# SPRINGFIELD GREEN OFFICIAL DEVELOPMENT PLAN MODIFICATION NO.4

OFFICIAL DEVELOPMENT PLAN MODIFICATION

### INTENT OF MODIFICATION NO.4

This Springfield Green Official Development Plan (ODP) Modification No. 4 amends the approved Springfield Green Official Development Plan Modification No. 3, recorded at reception No. 2008104880, with the following changes:

SHEET 2 OF 6

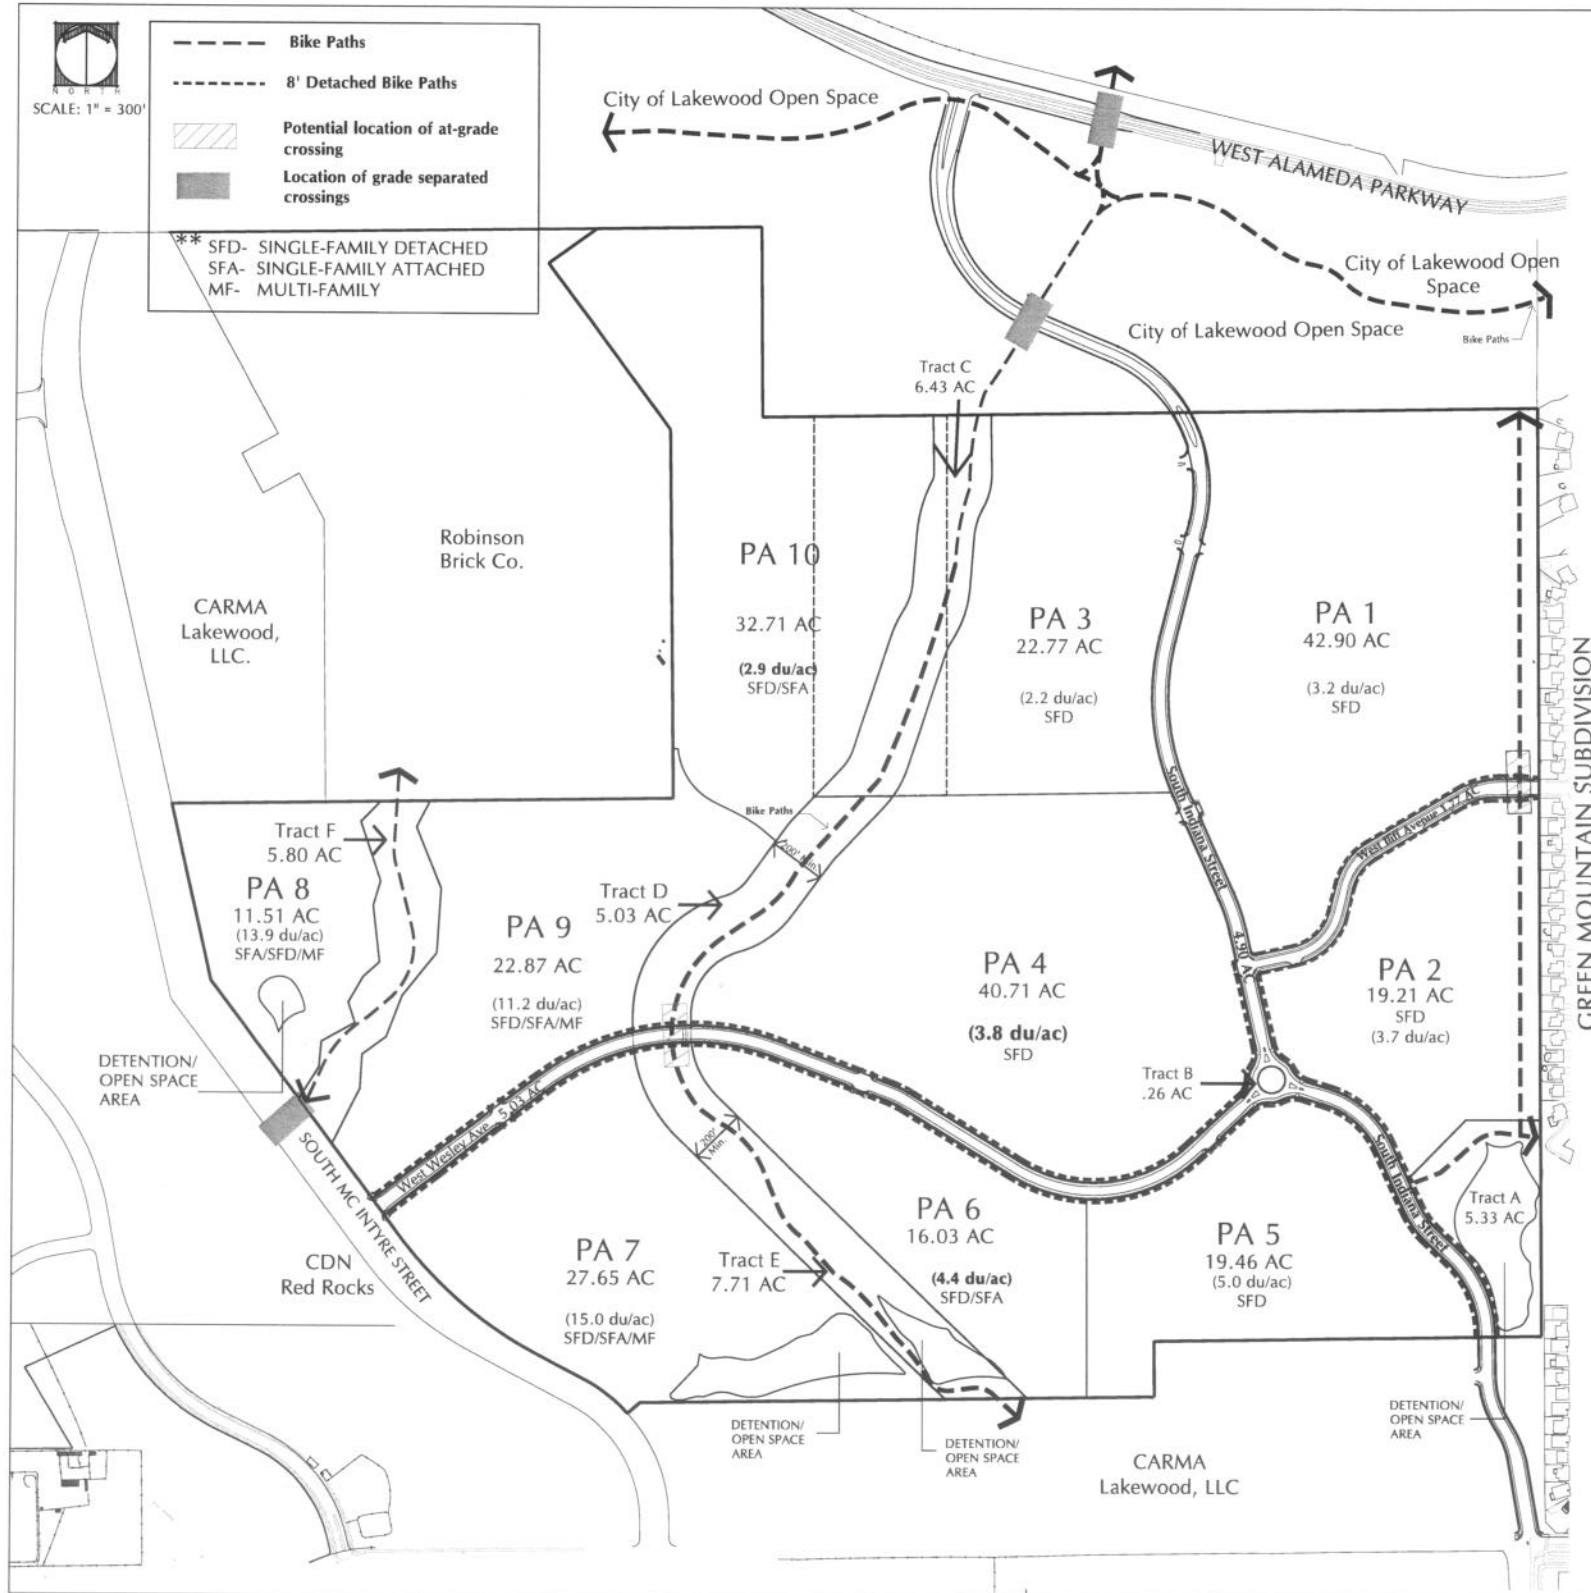
- 1. Revision to the density allocation of the Master Plan as described in Note 1 on Sheet 2 of 6.
- 2. Minor language revisions.

- NOTE 1: This Springfield Green ODP Modification No. 4 makes the following adjustments: PA-4 unit increase of 13 units or approximately 9.2%, per the provisions of Section M. Modifications to the Master Plan, specifically c., of the Springfield Green ODP Modification No. 3, and minor language revisions.

Planning Area (PA)	Land Use**	Density (du/ac)	Units	Acreage (AC)
		Max	Max	
1	SFD	3.2	136	42.90
2	SFD	3.7	71	19.21
3	SFD	2.2	49	22.77
4	SFD	<b>3.8</b>	<b>155</b>	40.71
5	SFD	5.0	97	19.46
6	SFD/SFA	4.4	70	16.03
7	SFD/SFA/MF	15.0	414	27.65
8	SFA/SFD/MF	13.9	160	11.51
9	SFD/SFA/MF	11.2	256	22.87
10	SFD/SFA	2.9	94	32.71
<b>SUBTOTAL</b>			<b>MAX. 1,502</b>	<b>255.82</b>
Tract A	Detention/Open Space			5.33
Tract B	Open Space			.26
Tract C	Open Space			6.43
Tract D	Open Space			5.03
Tract E	Detention/Open Space			7.71
Tract F	Open Space			5.80
<b>SUBTOTAL</b>				<b>30.56</b>
West Wesley Avenue	R.O.W.			5.03
South Indiana Street	R.O.W.			4.90
West Iliff Avenue	R.O.W.			1.77
<b>SUBTOTAL</b>				<b>11.70</b>
<b>TOTAL</b>		<b>5 du/ac*</b>	<b>MAX. 1,502</b>	<b>298.08 acres</b>
